PRJ2018-000053

Amended Exhibit Map RPPL2021009478 (For TR53933)

SUBDIVISION COMMITTEE REPORT

Proposal to install a 45 foot Soil Nail Wall ("SNW") in lieu of a previously proposed 1:1 slope cut for approved Tract Map No. TR53933.

AMENDED EXHIBIT MAP
TENTATIVE TRACT MAP NUMBER 53933
LOCATED IN THE UNINCORPORATED TERRITORY OF THE COUNTY
OF LOS ANGELES, STATE OF CALIFORNIA
JULY 26th, 2021

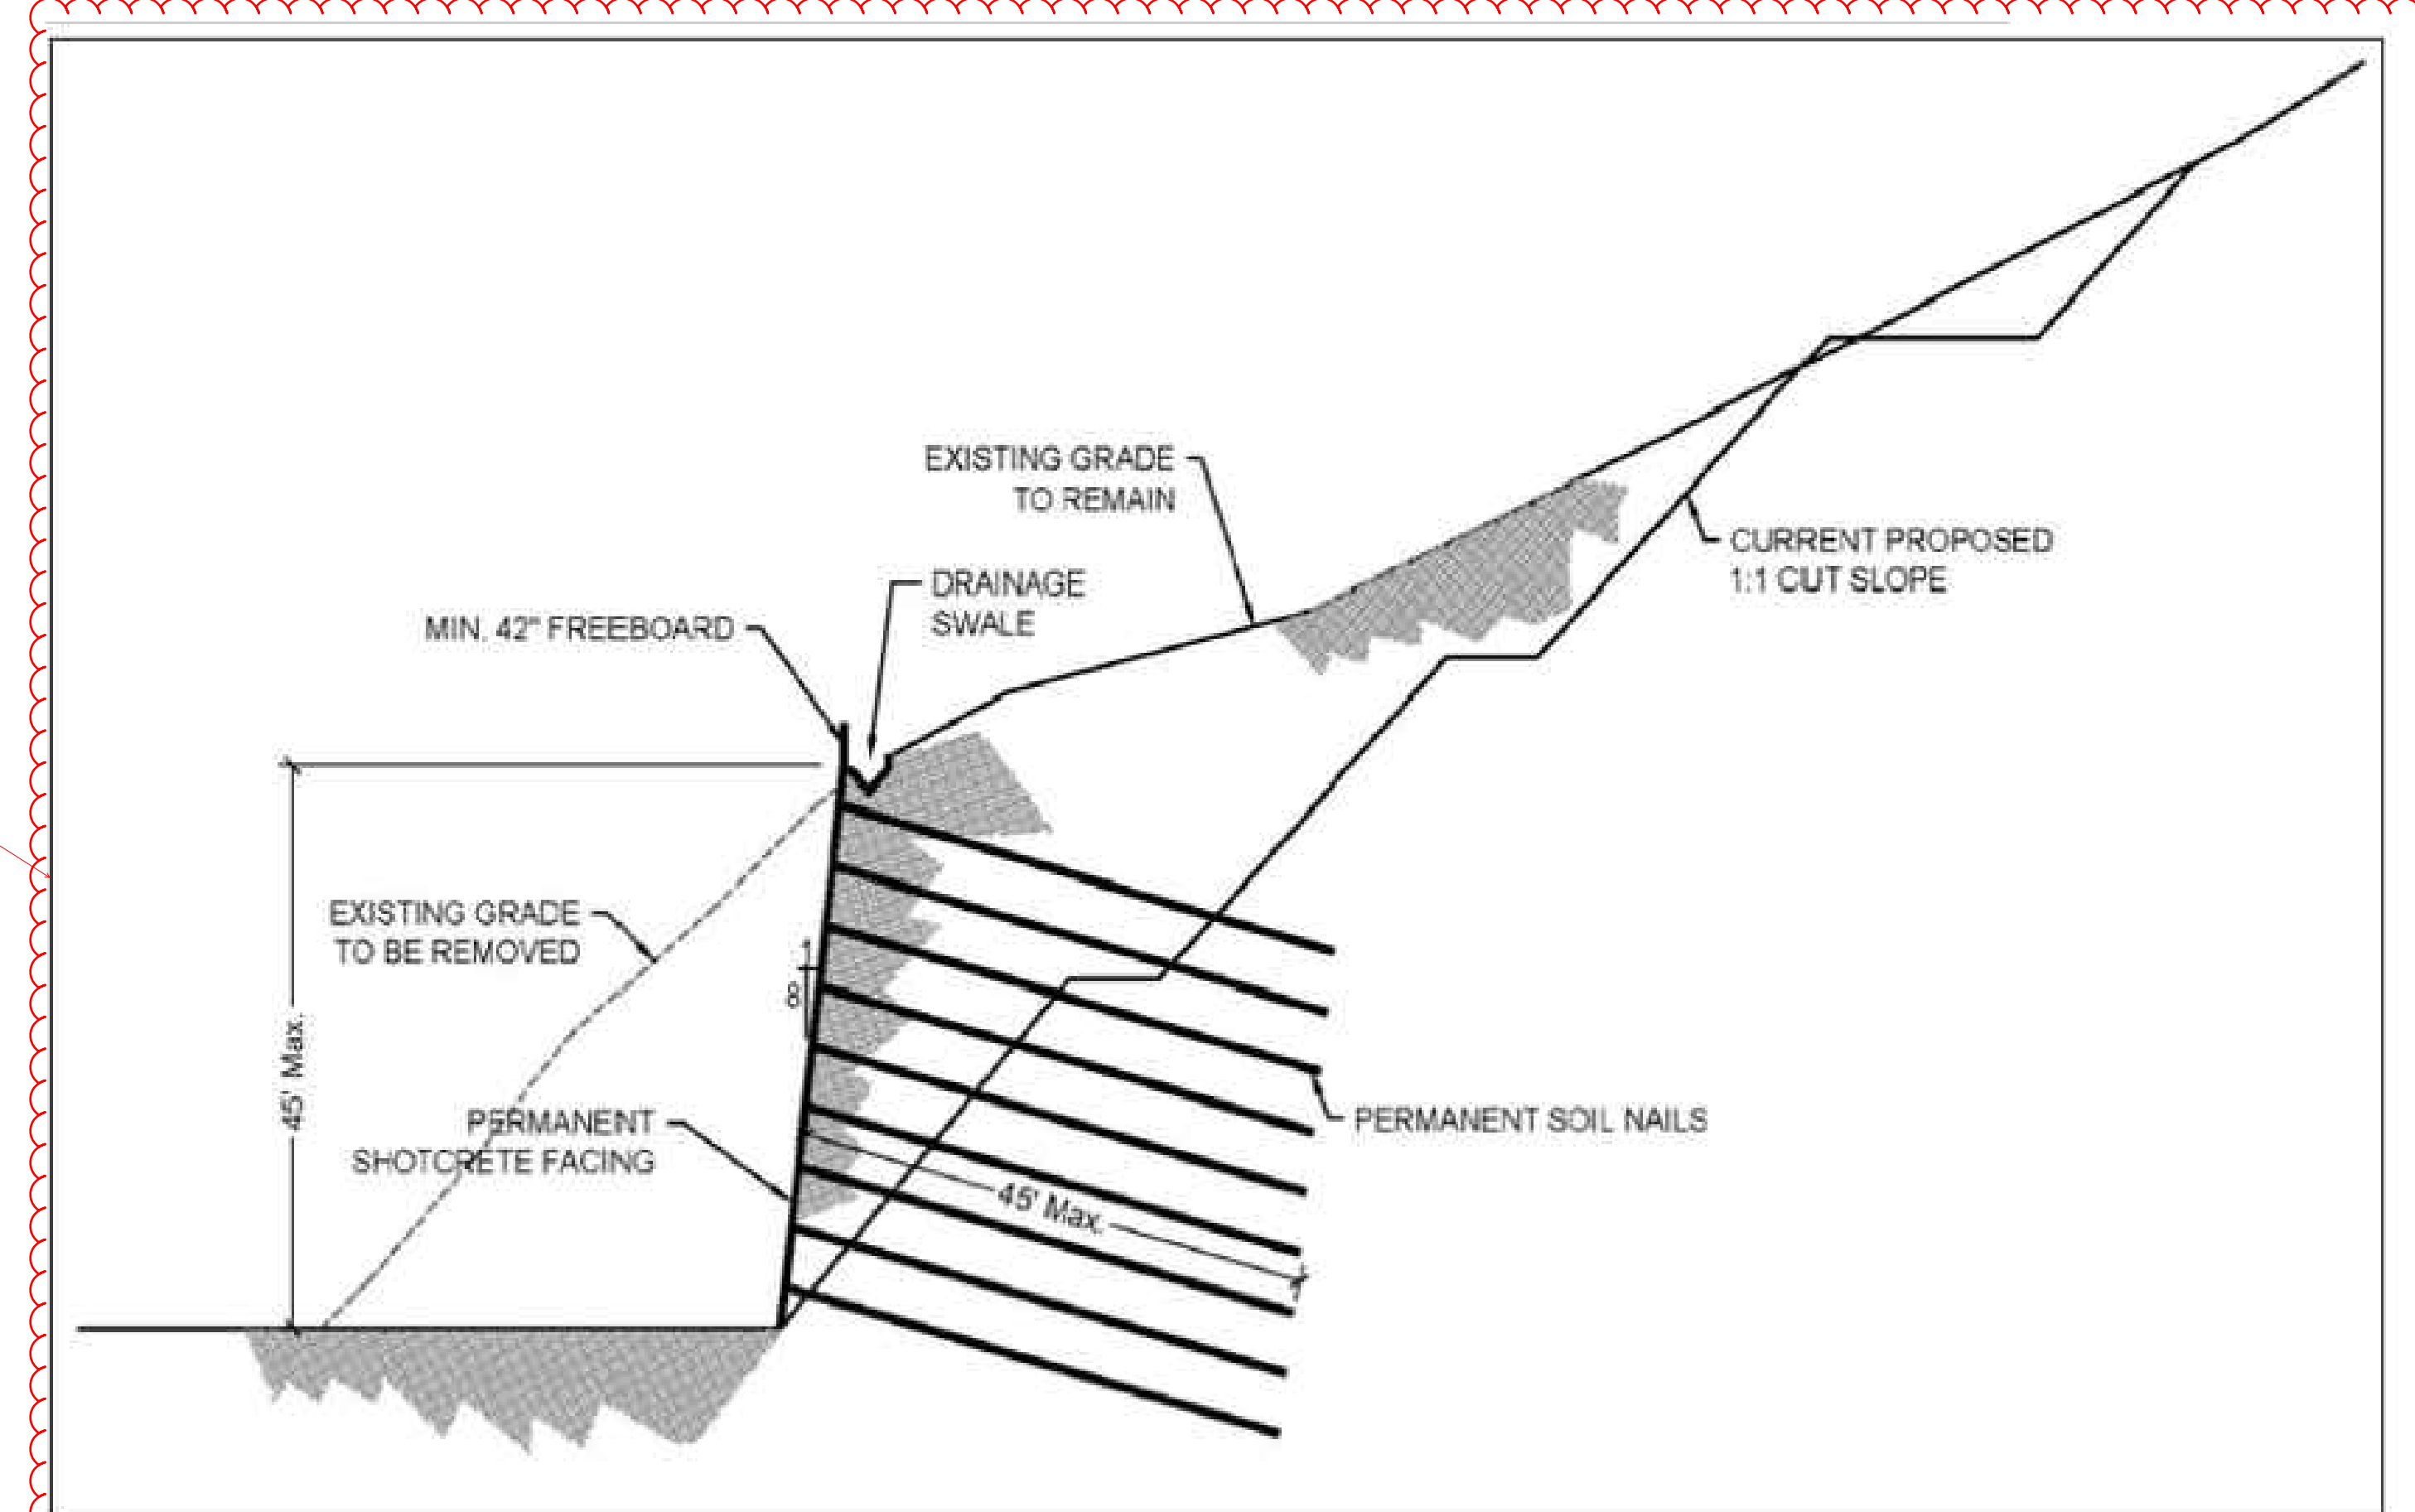
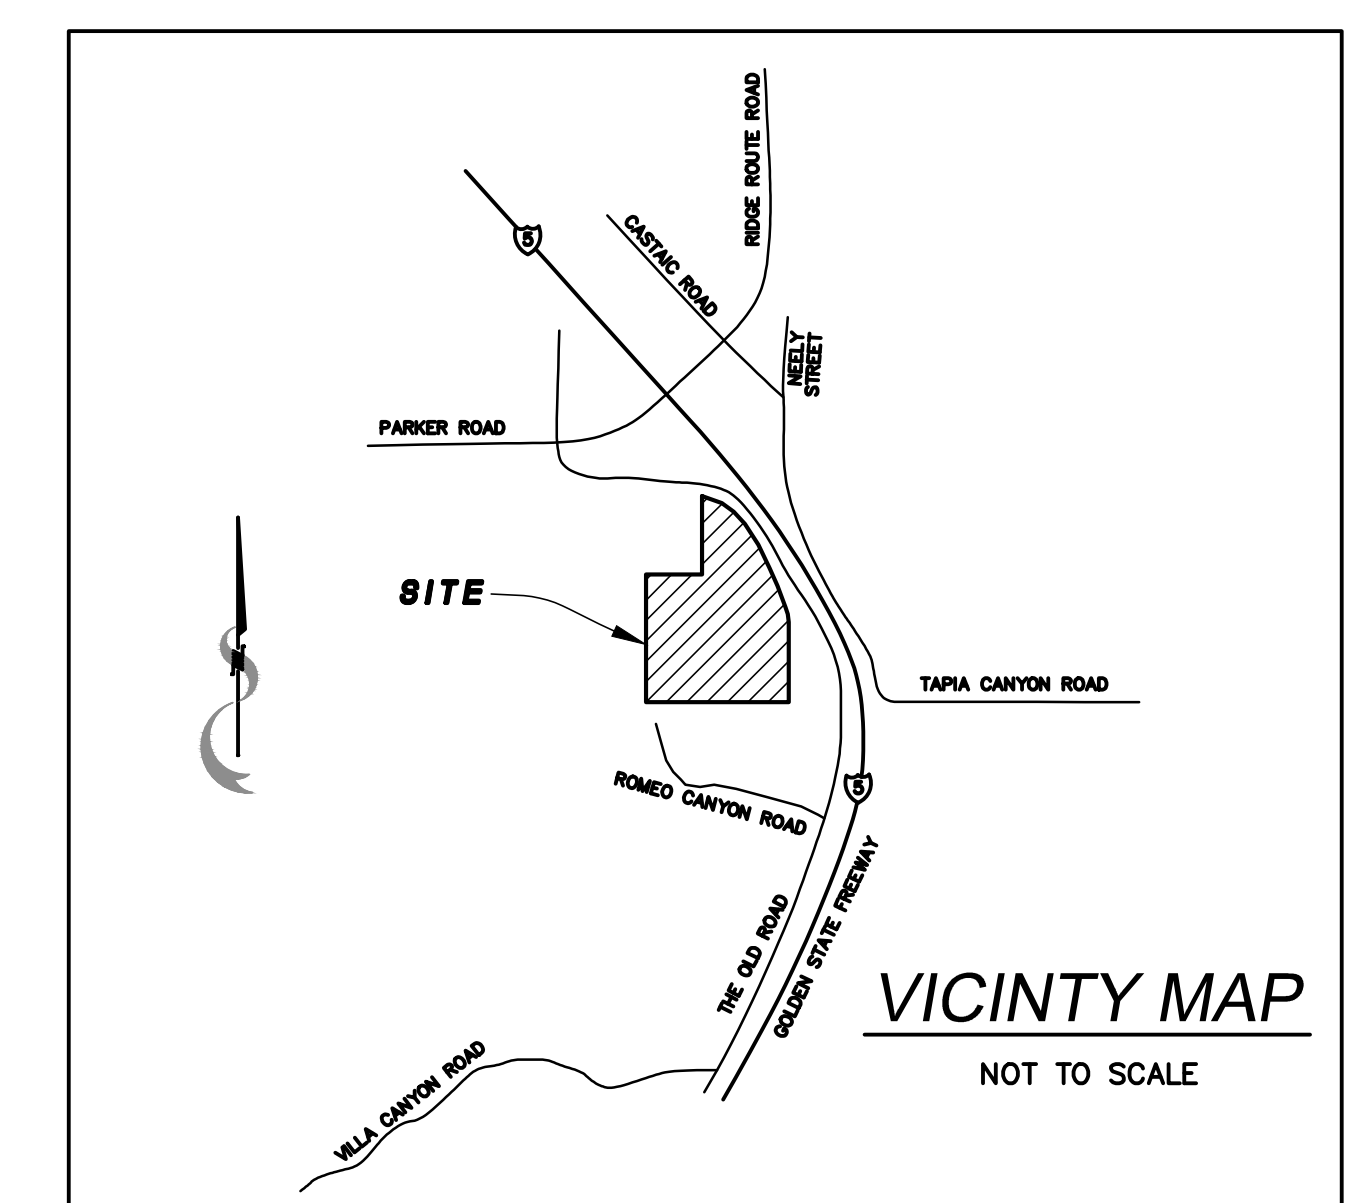
2. Provide detailed cross section of the SNW. Provide height and material.

1. A revised amended tentative map and exhibit map is required to show the following additional items:
 - a. Distance from toe of proposed wall to line of right of way.
 - b. How to handle debris flow captured or conveyed by the proposed wall. Provide the volume and flow rate of the debris flow and proper facility to handle such as basin and access road. Hydrology study is required and must be approved by the Drainage Section of the Land Development Division.

1. The proposed Soil Nail Wall Concept is currently under consideration by GMED and Design Division. The concept needs to be approved by these Divisions before it can be deemed acceptable.:

1. A revised amended exhibit map is required to show the following items:
 - a. Call out location of existing sewer main lines to serve the proposed development with the PC or CI number.
 - b. Show how the proposed development is to be served by proposed on-site public sewer.

THIS CONCEPT HAS NOT
BEEN APPROVED BY GMED
AND DESIGN DIVISION
